**New Albany Planning Commission**  
Monday, March 16, 2020 7:00pm

**Planning Commission Staff Report  
March 16, 2020 Meeting**

## Development Review

project name Shoppes at Smith's Mill Road  
prepared for City of New Albany  
date March 06, 2020  
date received February 21, 2020

SHEET INDEX	
TITLE SHEET	C-001
FINAL DEVELOPMENT PLAN	C-002
OVERALL GRADING PLAN	C-003

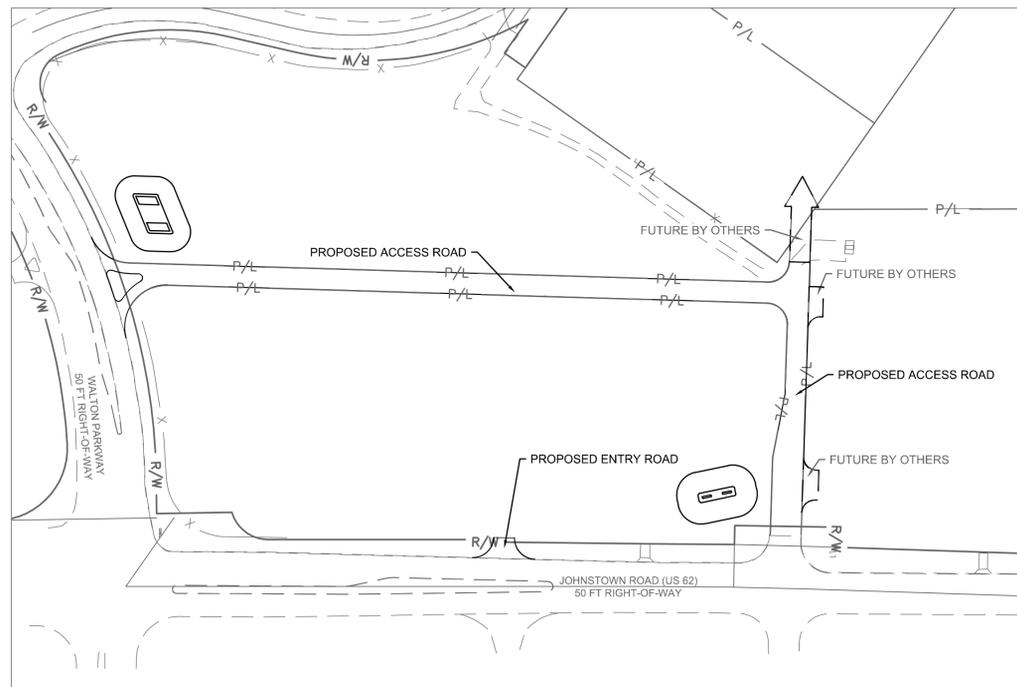
7. The Site Data Table on Sheet C-002 shows the site area as 87,365 SF. The zoning exhibit shows a Subarea A and B totaling 12.47 acres. Please revise the Site Data Table.
